# Access Compliance Report

## Public Rights-of-Way

### (Curb Ramps)

| Intersection ID: 45515 | Main Street: COTTON_PRESS_RD | Cross Street: HEDGEROW_PARK_RD | Location: NE           |

| ADA ID: 2F038664F5F1   | Ramp Type: Combination1Diag  | Initial Pass/Fail: Fail        | Overall Compliance: No |

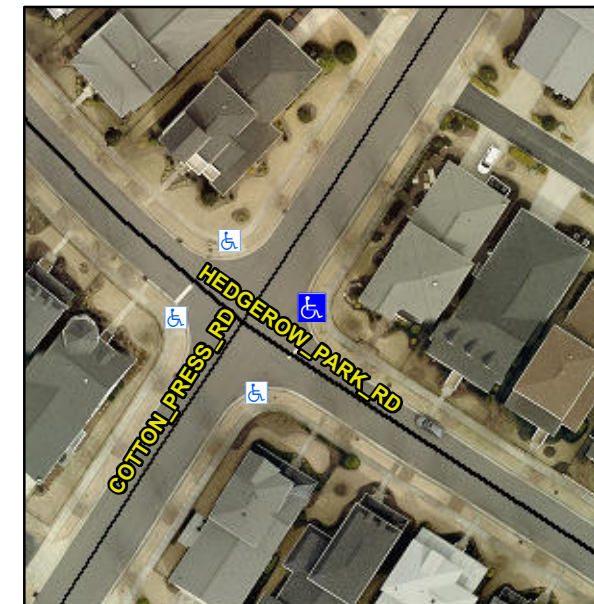
Surveyor Notes:

**RT RP < 5%**

PROW/ADA:

**R304.5.1, R304.2.2, R304.5.3**

Possible Solutions:

**Remove & Replace Curb Ramp With Two New Directional Ramps or Equivalent.**
